ELECTRONIC MODULAR SWITCHING SYSTEM KX-T123210DB/KX-T123210D

Installation and Operation Manual for Added and Changed Features

All the programming procedures described in the Installation Manual have been modified. Delete the step 2; "Press the NEXT button" from every feature of the programming in another Installation Manual. See the example below — the portion that should be deleted is shown shaded.

Example of Programming

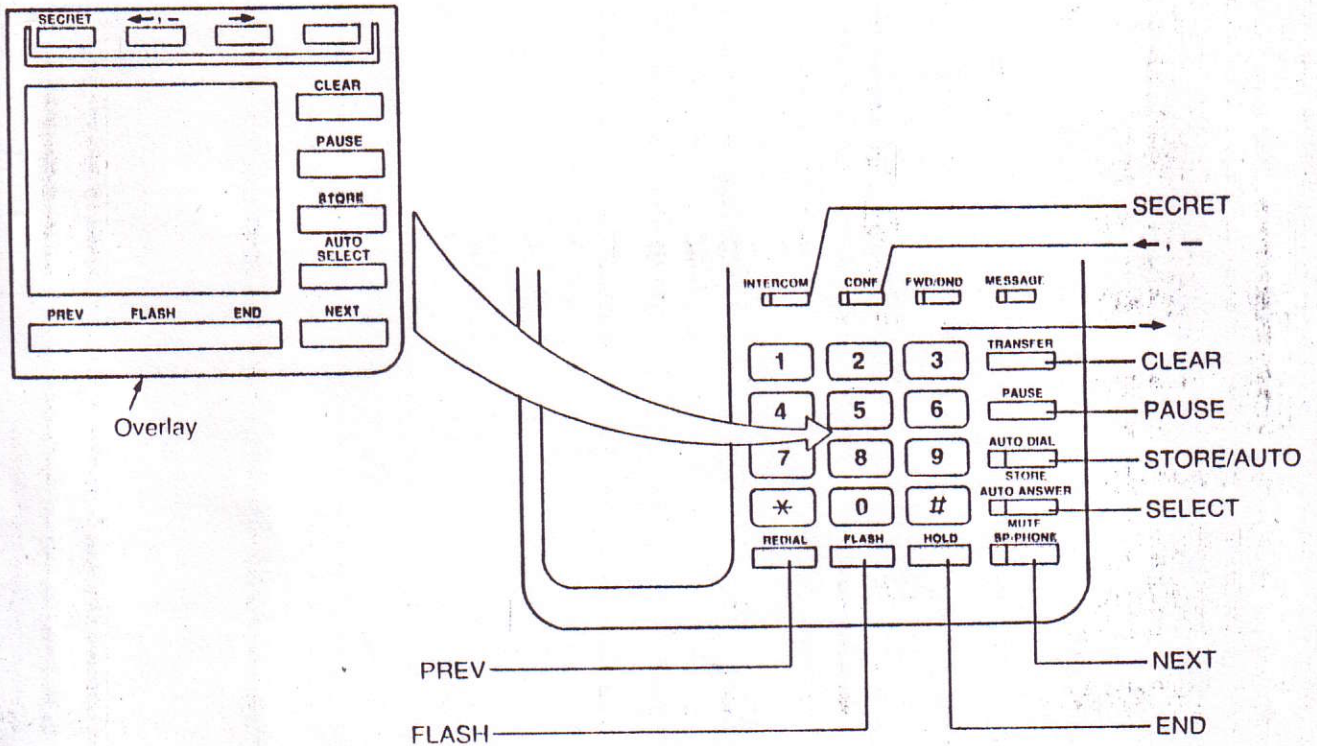
This manual describes the revised procedures from which the step 2 has already been deleted, as "Revision" below.

Original	Revision
<div style="border: 1px solid black; padding: 5px; margin-bottom: 10px; text-align: center;"> AB = [0] [0]: speed access code 00 ⋮ [9] [9]: speed access code 99 </div> <div style="border: 1px solid black; padding: 5px; margin-bottom: 10px; text-align: center;"> CD = [8] [1]: access number of Trunk Group 1 ⋮ [8] [8]: access number of Trunk Group 8 </div> <p style="text-align: center;">[01][NEXT][AB][CD][phone number][MEMORY][END]</p> <div style="text-align: center; margin-top: 10px;"> ↑ [SELECT] </div>	<div style="border: 1px solid black; padding: 5px; margin-bottom: 10px; text-align: center;"> AB = [0] [0]: speed access code 00 ⋮ [9] [9]: speed access code 99 </div> <div style="border: 1px solid black; padding: 5px; margin-bottom: 10px; text-align: center;"> CD = [8] [1]: access number of Trunk Group 1 ⋮ [8] [8]: access number of Trunk Group 8 </div> <p style="text-align: center;">[01][AB][CD][phone number][MEMORY][END]</p> <div style="text-align: center; margin-top: 10px;"> ↑ [SELECT] </div>

<ol style="list-style-type: none"> 1. Dial (01) or press the AUTO button. "Speed Dialing" will be displayed. 2. Press the NEXT button. "Speed NO? → " will be displayed. 3. Dial (00 through 99) or press the NEXT button, for speed access code entry. 4. Enter automatic line access number or trunk group number. 5. Enter the phone number. 6. Press the MEMORY button. The memory indicator will be lit. 7. <ul style="list-style-type: none"> ● To advance to the next speed access code, press the NEXT button. ● To return to the previous speed access code, press the PREV button. ● To go to the desired speed access code, press the SELECT button and then dial the speed access code. 8. Repeat steps 4 to 7, to program the other phone numbers. 9. To return to the initial programming mode, press the END button. 	<ol style="list-style-type: none"> 1. Dial (01) or press the AUTO button. "Speed NO? → " will be displayed. 2. Dial (00 through 99) or press the NEXT button, for speed access code entry. 3. Enter automatic line access number or trunk group number. 4. Enter the phone number. 5. Press the MEMORY button. The memory indicator will be lit. 6. <ul style="list-style-type: none"> ● To advance to the next speed access code, press the NEXT button. ● To return to the previous speed access code, press the PREV button. ● To go to the desired speed access code, press the SELECT button and then dial the speed access code. 7. Repeat steps 3 to 6, to program the other phone numbers. 8. To return to the initial programming mode, press the END button.

Call Transfer To Extension

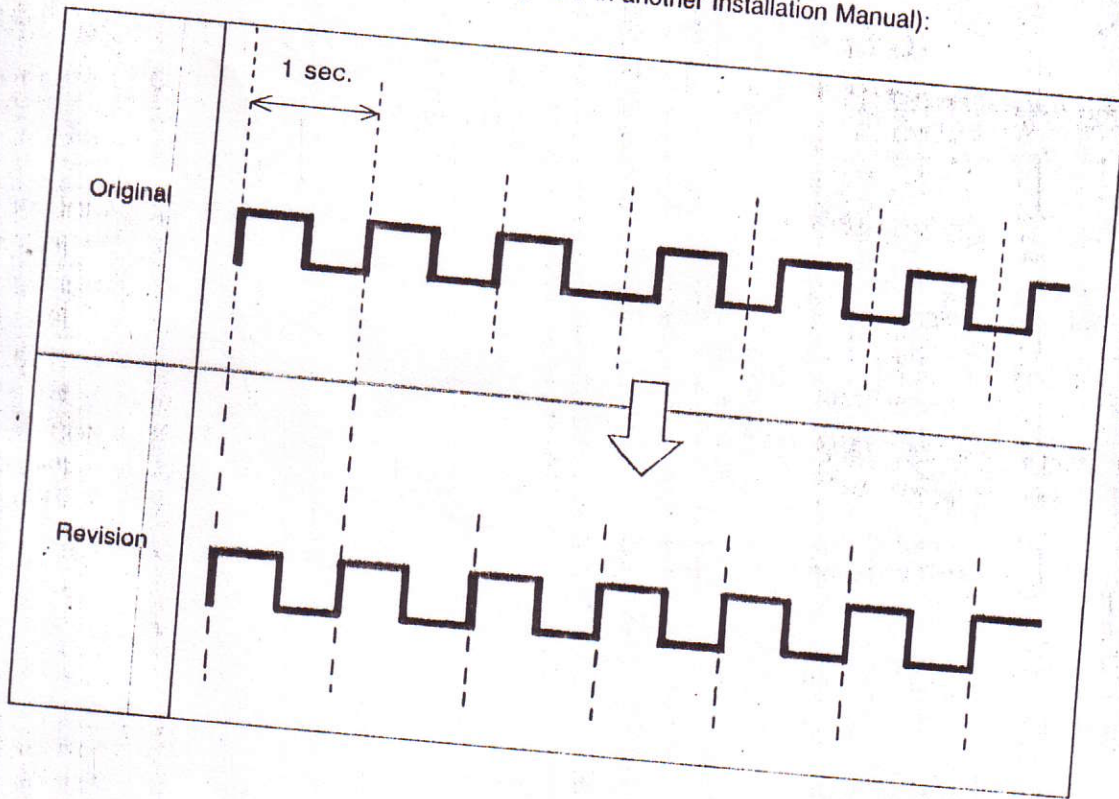
Pressing the TRANSFER button is also available to change the party to whom a call is transferred before hanging up.

If the called party is busy or does not answer, you may return to the calling party also by pressing the TRANSFER button.

Transfer Recall Time is changed from "30 seconds or 15 seconds" to "30 seconds or 2 minutes".
